ATTACHMENT 5

Peer Review Letters

**Re: Dendrobium Mine Extension Project
Independent Review – Subsidence & Height of Fracturing Assessments**

REPORT NO: 2201/01.1

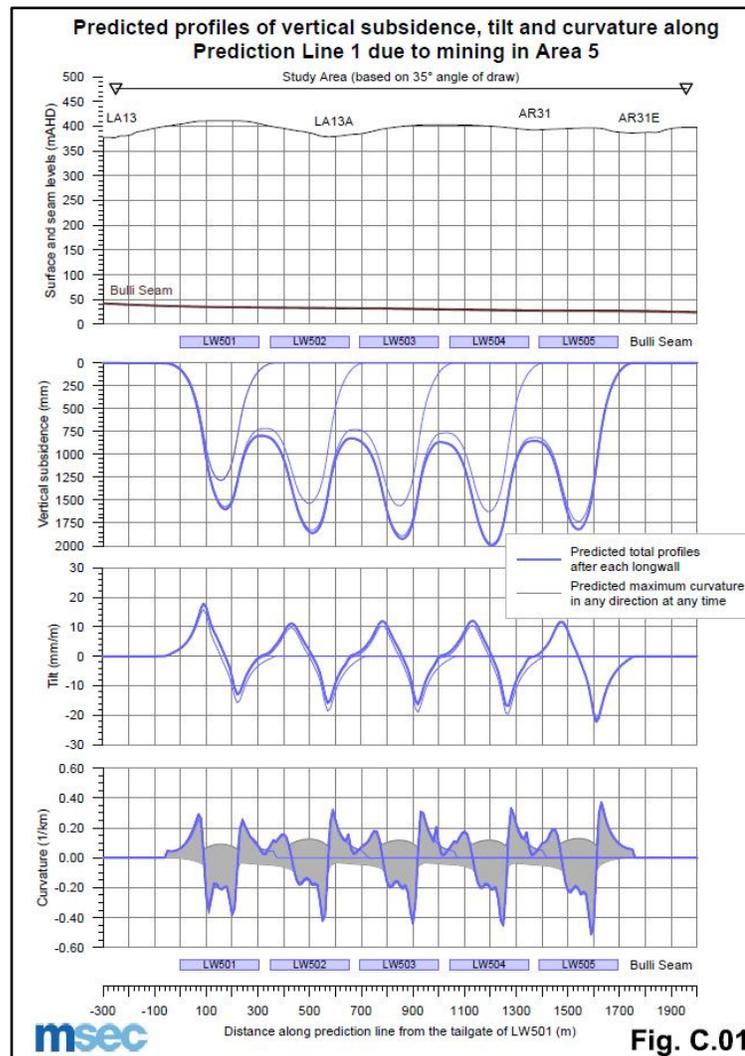
- 1) Subject to the previous commentary on the prediction methods used by MSEC, I am satisfied that the predicted subsidence effects reported by MSEC are reasonable, representing a conservative upper bound of expected magnitudes. I do not propose to comment on individual features or parameters, as reported by MSEC.
- 2) The following is an extract from the MSEC Report, showing MSEC Table 4.4, which summarises the major subsidence parameters for the Area 5 prediction, relative to Areas 3A and 3B. In all cases, the Area 5 values are significantly lower, and hence, more benign.

MSEC's Figure C-01 is also reproduced below to show a graphical representation of subsidence effects across a line extending over Longwalls 501 to 505 in Area 5.

Figure 0-1 Groundwater pressure profile for Area 3B (over-goaf bores)

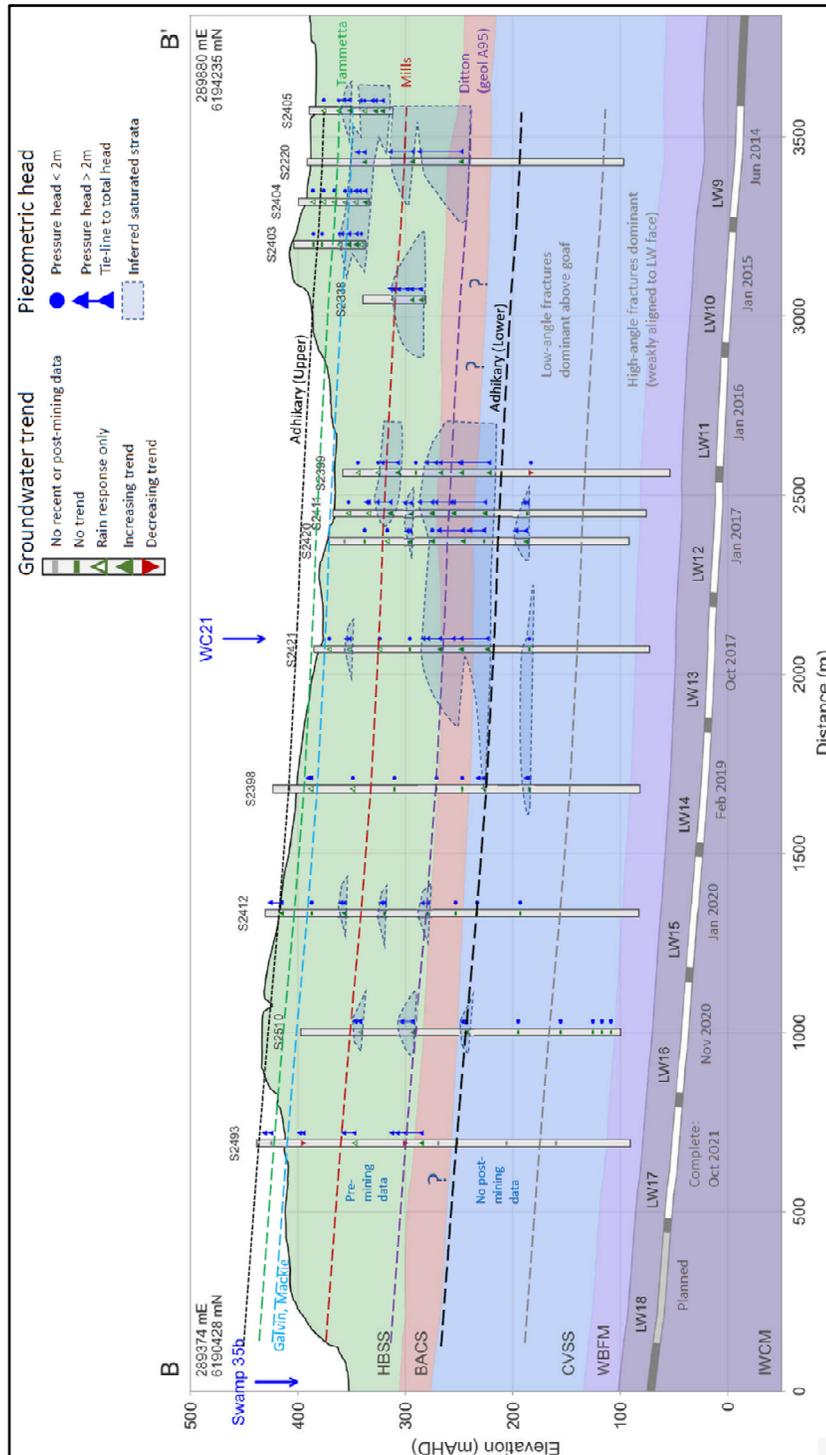
Evidence of this was provided by Watershed, earlier in their report, presented in Figure 2-19, which is reproduced below, for information. The areas where this behaviour has been observed are indicated by upward blue arrows on the boreholes, and shaded areas of inferred saturated strata. Evidence shows increasing regions of groundwater recovery, and some isolated perched aquifers within the Hawkesbury Sandstone, with some evidence extending down to and just through the Bald Hill Claystone also. The effect of time is also evident, with more evidence of this recovery above the older longwall panels, mined between 2014 and 2017.

It is understood that this diagram represents late 2021 data.

Figure 0-2 Profile illustrating estimated height and mode of fracturing in Area 5

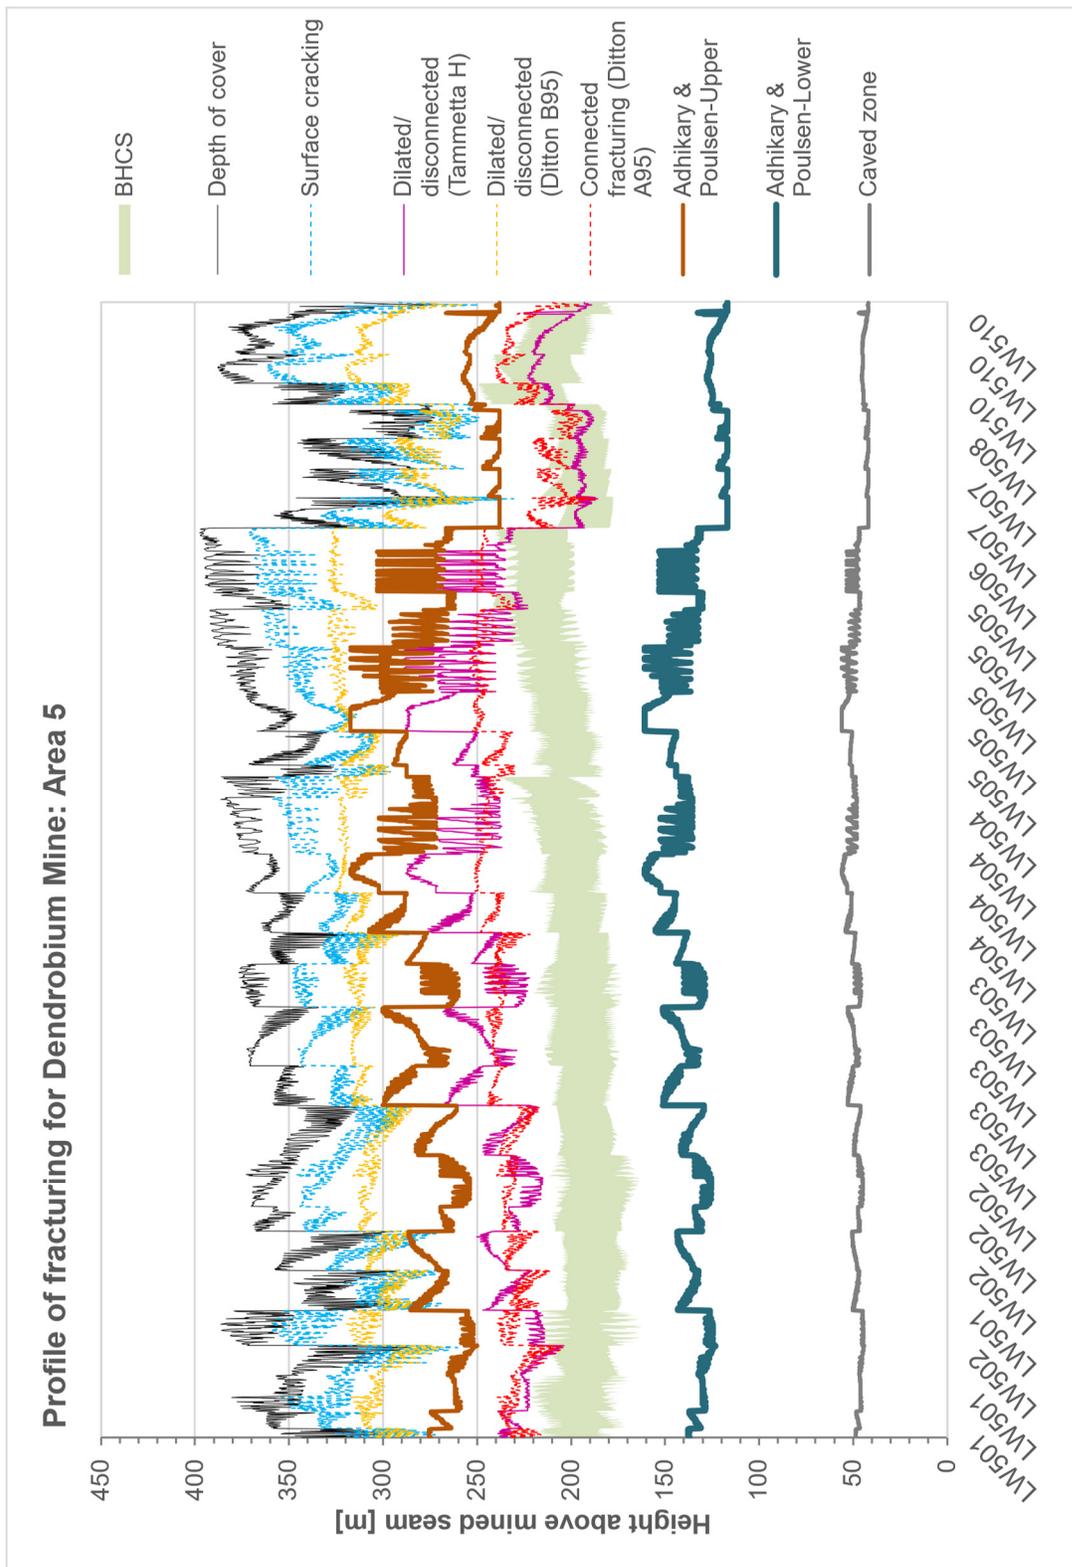
Watershed has concluded that gradational boundaries should be specified between the various conceptual zones above mining, with the Ditton & Merrick (A Zone) height of vertically connected cracking being a useful definition for the base of the constrained zone, but that depressurisation in the initial instance, will still occur above this horizon immediately post-mining (as per the Tammetta height). It is noted that there is not a significant difference in height between Ditton & Merrick and Tammetta for Area 5.

Figure 3-7 is reproduced below, from the Watershed Report, illustrating the results of the various models for various height parameters above Area 5. This shows both the Ditton & Merrick and Tammetta heights reporting into the base of the HBSS across Area 5, (i.e., above the marked Bald Hill Claystone horizon), although not connecting with the base of the surface fracturing zone (in contrast to the same calculations for Areas 1 to 3).

11) Pp93, Section 3.3.1 - Further to the above model development, Watershed draws a conclusion, which I fully support at this stage of the project, stating “*For conservatism, and without other evidence, the DFZ is assumed to extend above the connected fracture zone to the surface cracking zone across much of Dendrobium, including in Area 5. In general, this is supported by considering the maximum of the Ditton B95, Tammetta H, Adhikary-upper (orange, purple and green lines respectively)*”. (Note: DFZ is undefined in the Report, which should be rectified – understood to be Disconnected Fracture Zone).
